**Subject: Vermont Yankee Nuclear Power Station  
License No. DPR-28 (Docket No. 50-271)  
Technical Specification Proposed Change No. 262  
Alternative Source Term**

**Proposed Technical Specification Change No. 262**

**Attachment 5**  
**Vermont Yankee Nuclear Power Station**  
**Proposed Technical Specification Change No. 262**  
**Alternative Source Term**  
**Safety Assessment**

FigureA-1  
 VYNPS ALT Seismic Verification Boundary  
 100% Power

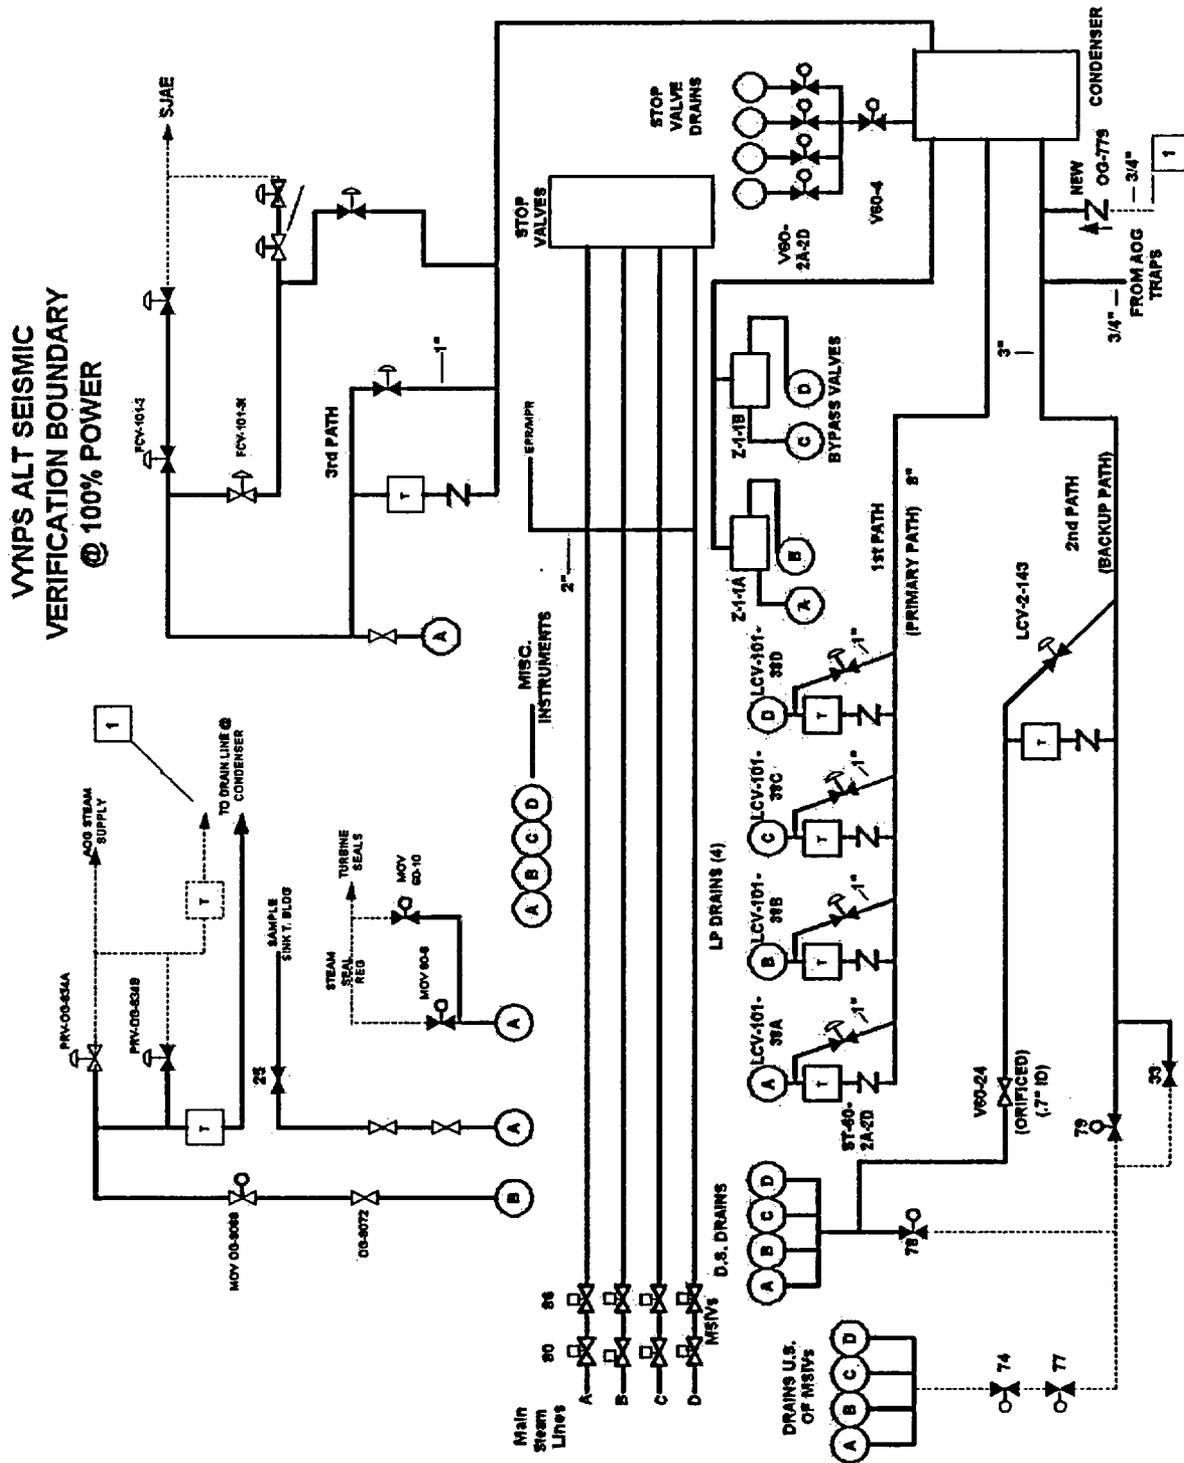
Vermont Yankee has identified the ALT drain paths and seismic isolation boundaries required to process the MSIV leakage for the Alternative Source Term (AST) analysis using the isolated main condenser strategy. Figure A-1 shows the ALT pathways that include the main condenser and the piping connected to the main steam lines between the (MSIVs) and the turbine stop valves along with associated valves when the plant is at 100% power. Figure A-2 is the same as Figure A-1 with the valves in the Post Accident drain pathway lineup. It should be noted that the normal position of several of the valves (e.g. PRV-OG-834B, FCV-101-35 and 36A) may be different from what is shown in Figure A-1. This is due to the required position at various power levels or operating philosophy. However, this has no effect on the required failure position.

A new ¾" check valve (OG-779) will be installed on the drain line downstream of the trap off the AOG steam supply line to the AOG building in line No. ¾"- MS-189-D3 near the condenser.

The seismic evaluation and any required modifications will be completed during Refueling Outage 24 (RFO 24) in April 2004.
